**NYC DEPARTMENT OF ENVIRONMENTAL PROTECTION
BUREAU OF ENGINEERING DESIGN AND CONSTRUCTION
CROTON FACILITY MONITORING COMMITTEE MEETING MINUTES
THURSDAY, APRIL 15, 2010 – 7:00PM**

**NYC Department of Environmental Protection
Bureau of Engineering Design and Construction
Croton Water Treatment Plant - Jerome Park Reservoir
Contract CRO-312OS Regulatory Review Fact Sheet
April 15, 2010**

Re: EPA/NYCDEP CRO-3120S
Jerome Park Reservoir
South Ramp
B/Bronx, Bronx County
SHPO #06PR02855

Re: Jerome Park Reservoir, South Basin Ramp
Response to NYSOPRHP Correspondence, March 31, 2010

PARTIAL PLAN AT TOP OF EXISTING RESERVOIR WALL

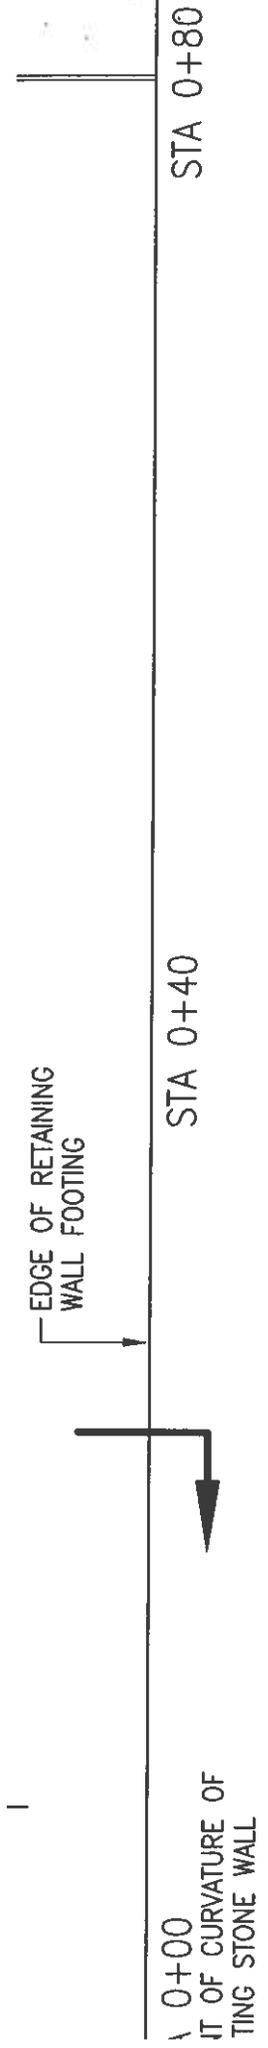
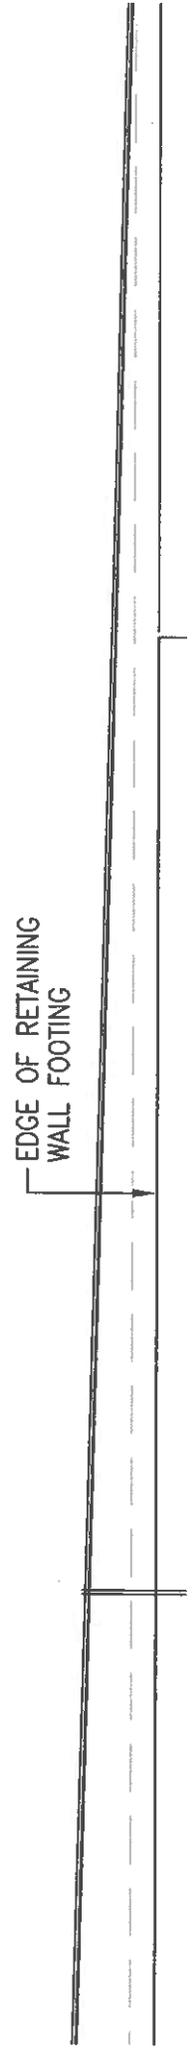
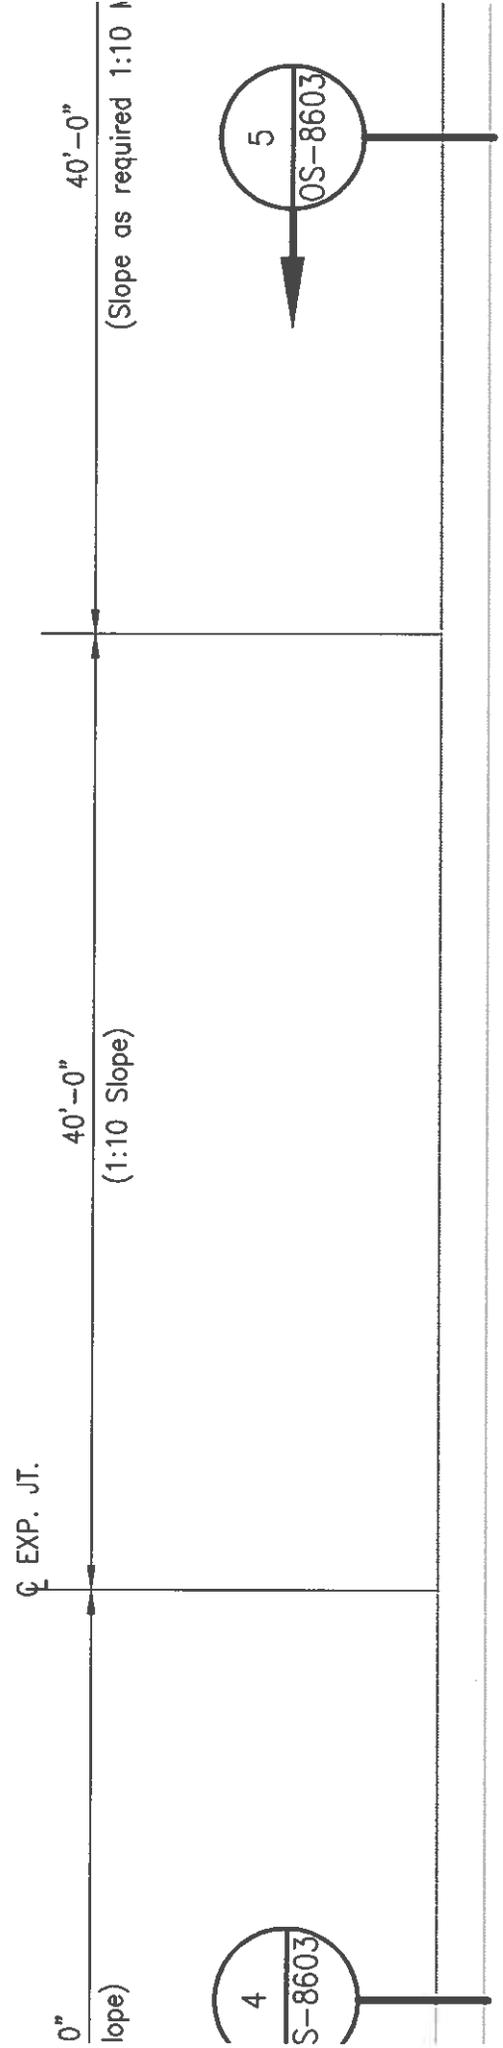
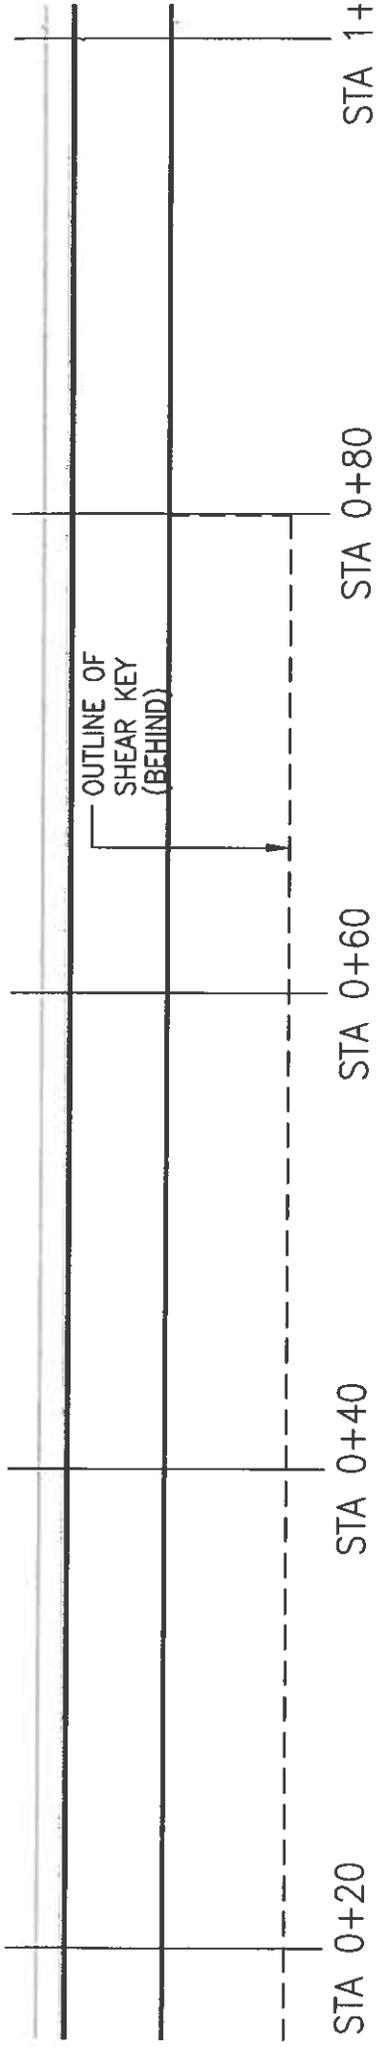
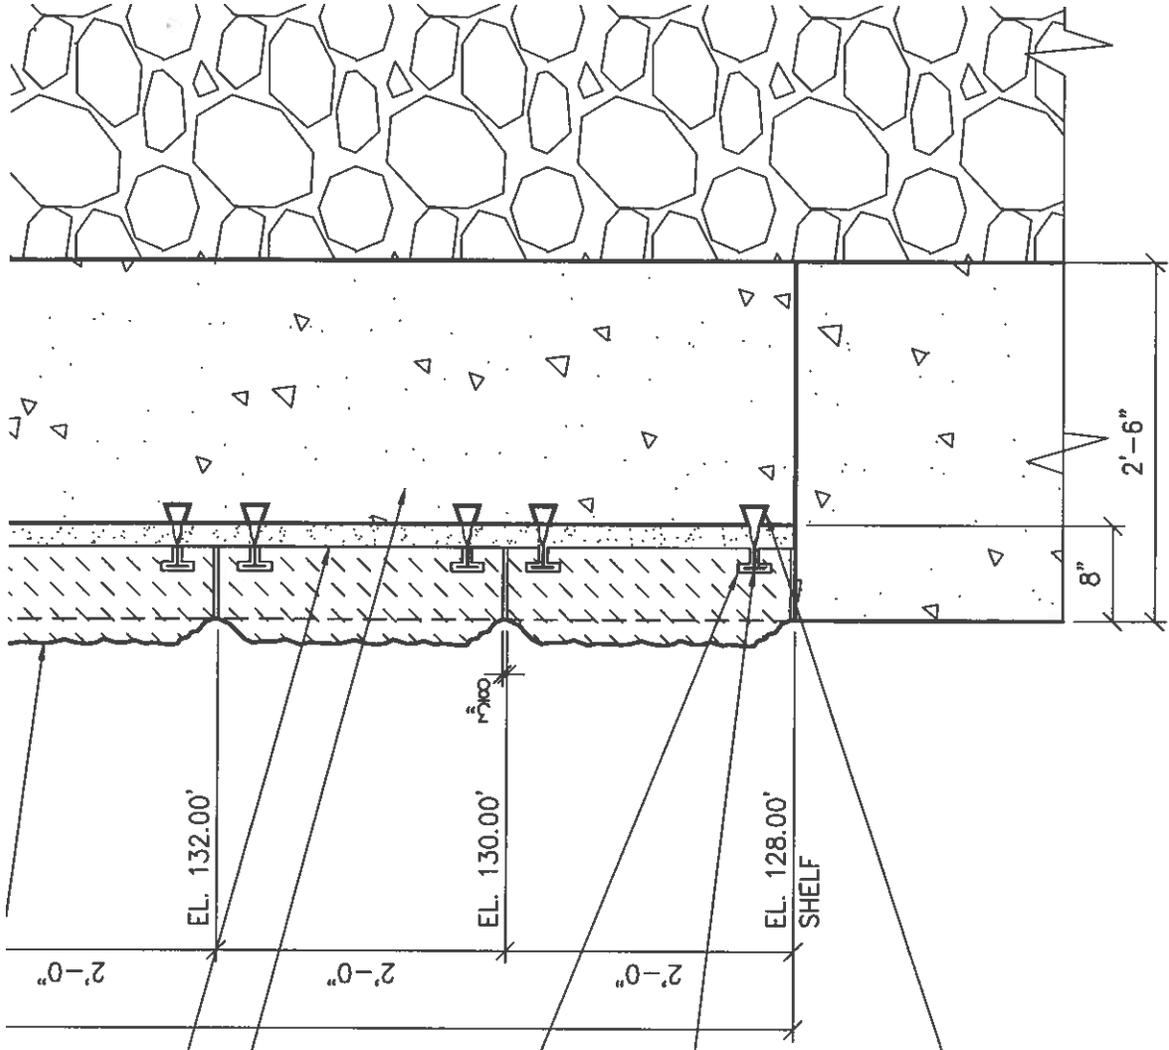
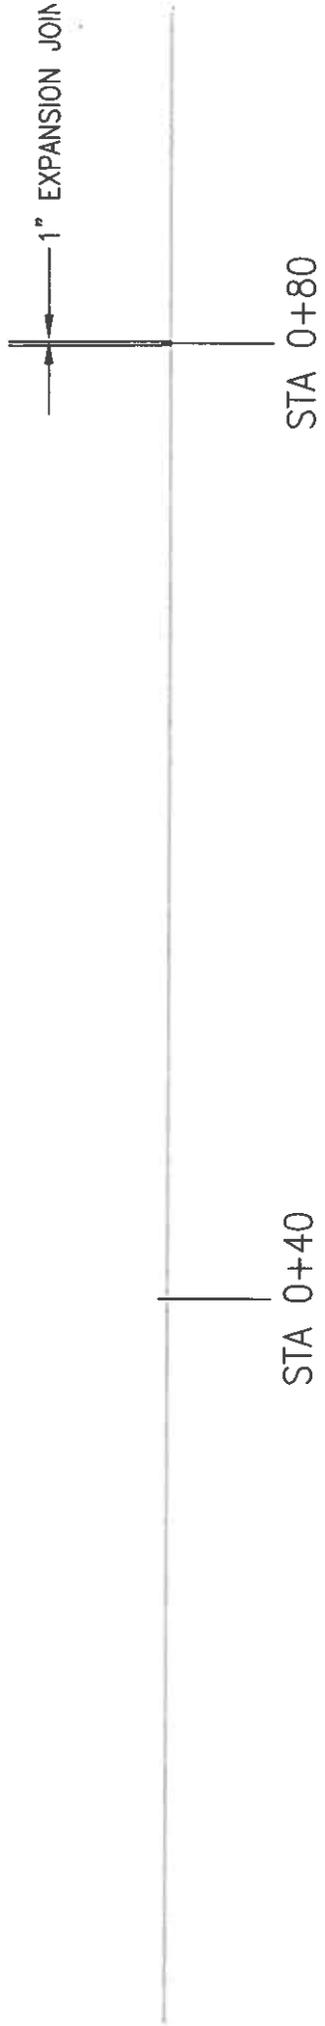
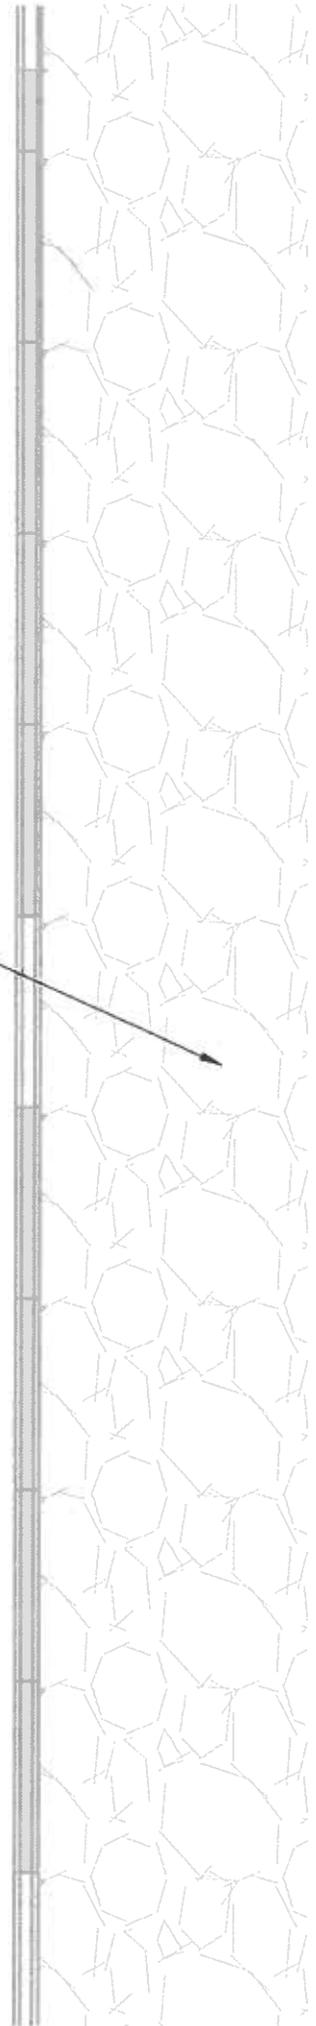
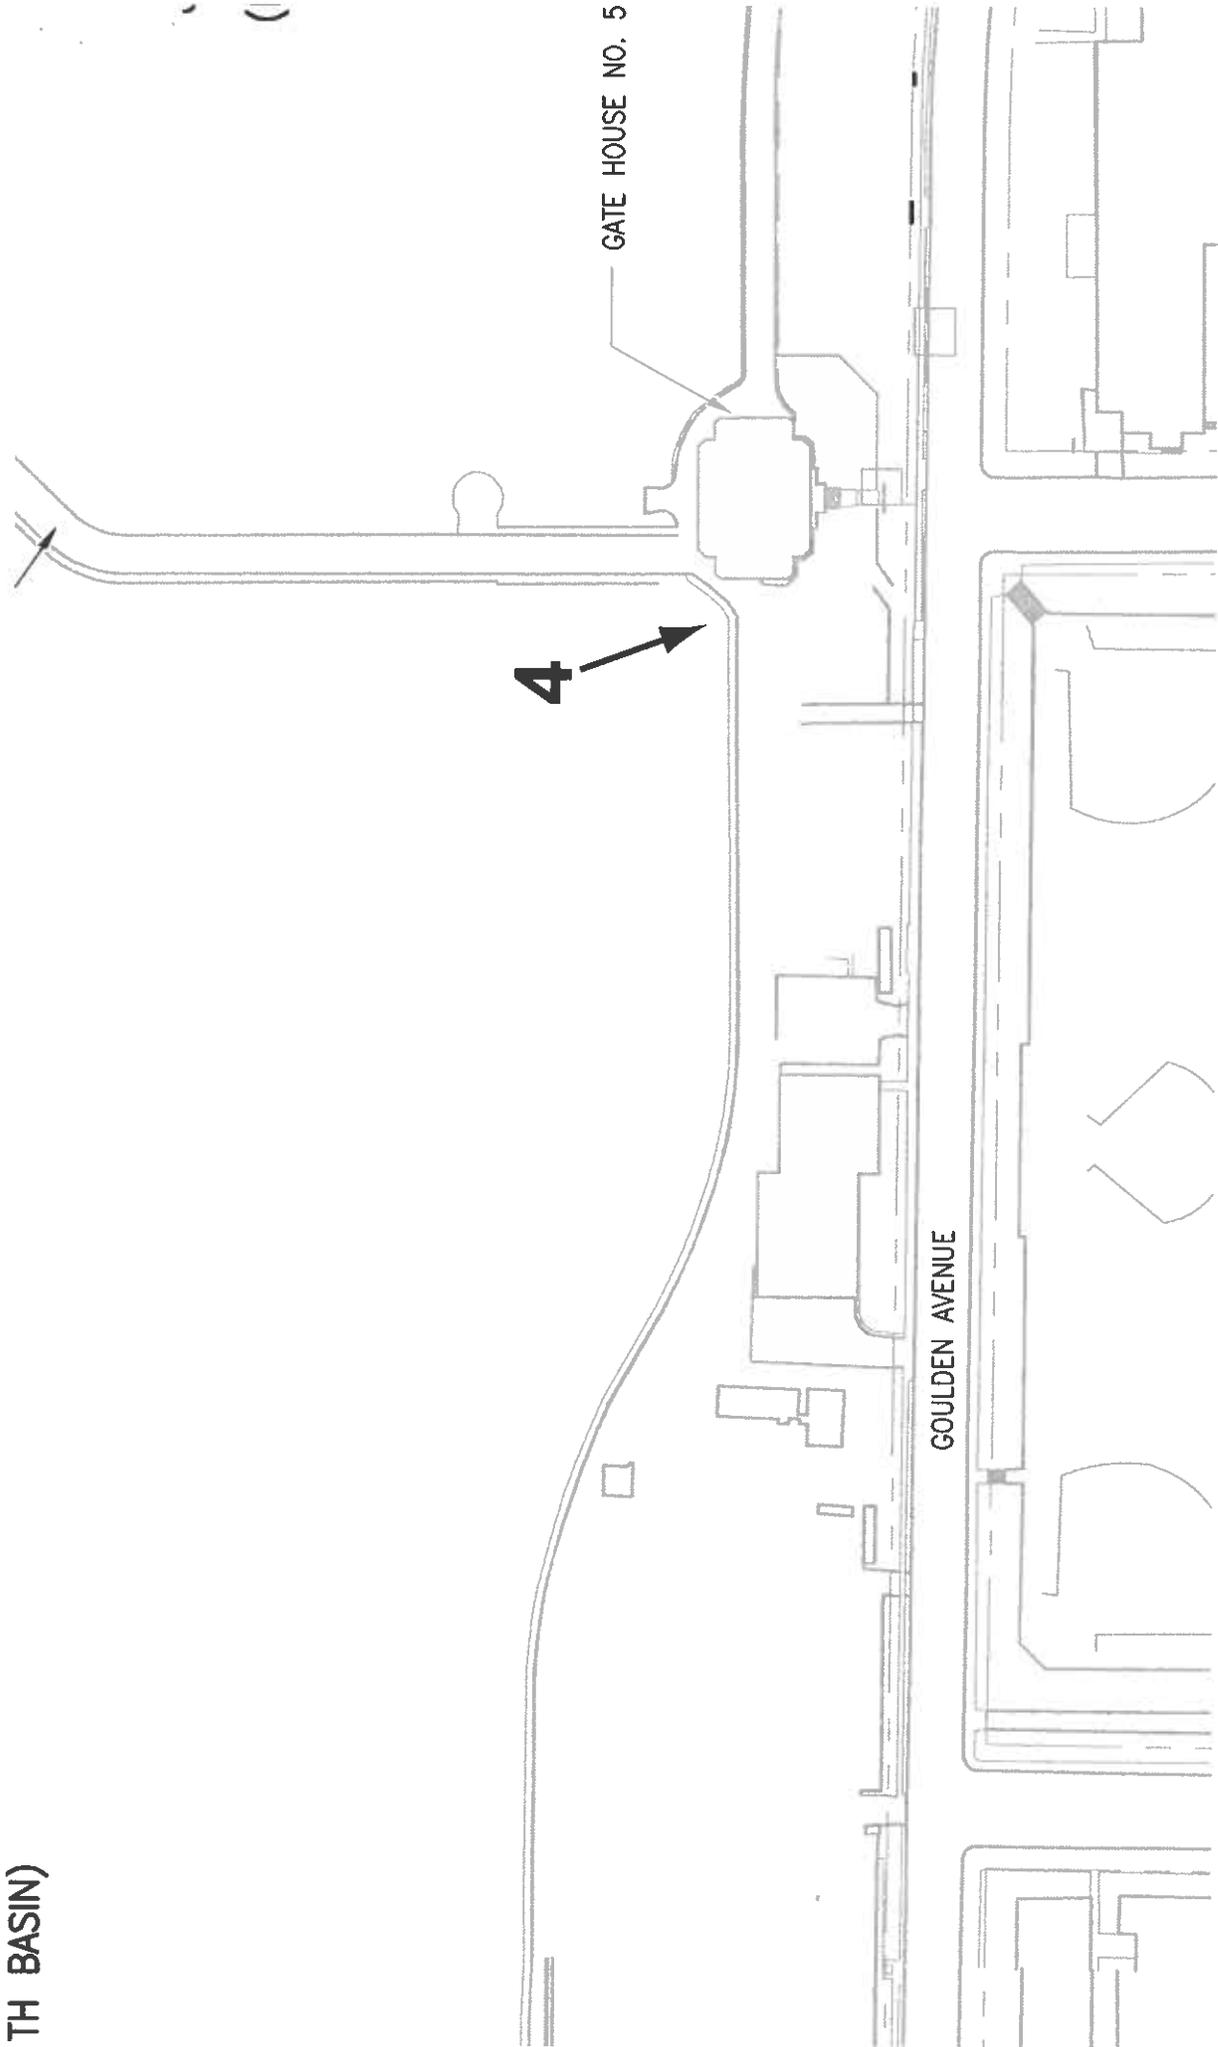
Our concern is that the ramp installation be designed to minimize damage to the reservoir walls and to be, in theory, reversible. Based on the additional information you have provided, these goals have been met and we can support the ramp installation as proposed. We note that the areas of the inner reservoir walls that will be obscured by the ramp are of uncoursed fieldstone and not the ashlar masonry found elsewhere above the water line and on the reservoir's exterior. In addition, the detailed drawings show that care has been taken to avoid attachments to the historic masonry wall and to isolate the poured concrete road surface from the reservoir wall by an expansion joint.

The South Basin Ramp work will begin by constructing a new free standing wall with its foundation parallel to the existing stonework JPR wall (Drawings OC-8602, OS-8601 and OS-8602). The foundation for the free standing wall will require removal of a portion of the existing concrete JPR floor, which will be replaced after the foundation is completed. This wall will be constructed with reinforced concrete and will have an ashlar stone veneer rock face on the portions that are above the low-water line. Also, this new wall will not tie into the existing stonework wall (Drawing OS-8605). The height of the retaining wall will be progressively lower as to create the ramp as it connects to the base of the Reservoir floor (Drawings OS-8602 and OS-8605). Once the free standing wall is completed, gravel will be placed and compacted in the space between the free standing wall and the existing stonework wall (Drawing OS-8602, OS-8603, and OS-8604). The design calls for careful consideration and protection of the existing stonework to ensure that the existing JPR wall is not damaged. When the gravel fill is compacted and complete, a 12" concrete road surface will be laid on top, with 1" expansion joints between the concrete and both the free standing wall and the existing stone wall (Drawing OS-8603). The use of expansion joints ensures that the ramp will have no physical impact to the existing wall. Furthermore, since the new ramp has no permanent attachments to the JPR wall, it could be removed in the future with no lasting consequence, although currently DEP has no plans to do so.
